Technical Service Information

CHRYSLER 45RFE NEW SOLENOID PACK

CHANGE: A new design Solenoid pack was introduced as a running change in the 2004 model year.

Figure 1

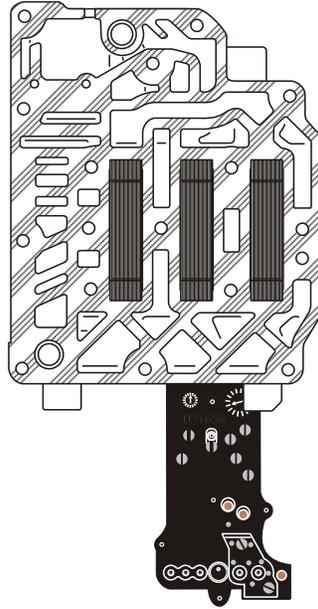
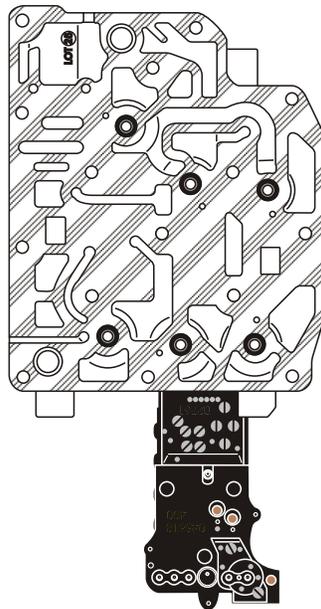
- (1) SOLENOID PACK - Totally re-designed casting with changes in the worm track area as shown in Figure 1.
- (2) SOLENOID BODY SCREEN AND GASKET ASSEMBLY - Changed to accommodate the changes in the Solenoid Pack and is illustrated in Figure 2.
- (3) TRS/ AND 23 WAY CONNECTOR - Changed to accommodate internal solenoids. See Figures 3 and 4 for early design and Figures 5 and 6 for updated design.
- (4) RANGE SENSOR SELECTOR PLATE - The pocket for the T41 pin was made deeper and is illustrated in Figure 7.

Figure 7

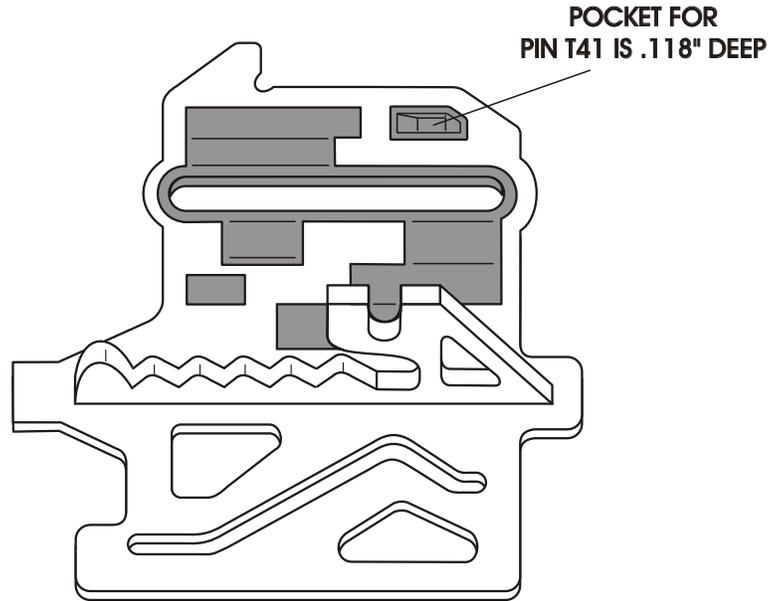
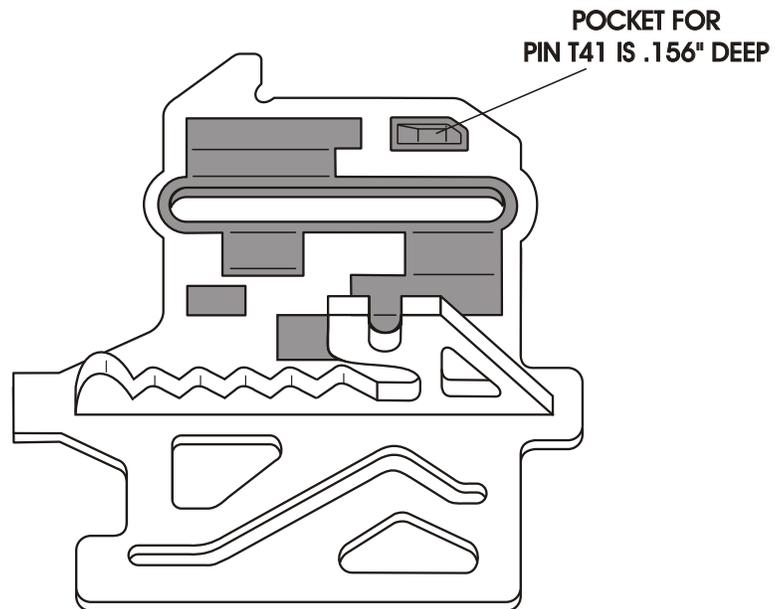
Special Note: The 1999 - 2003 range sensor plate can be modified and used with the updated Solenoid Pack. by making the T41 pocket .040" deeper (Figure 7).
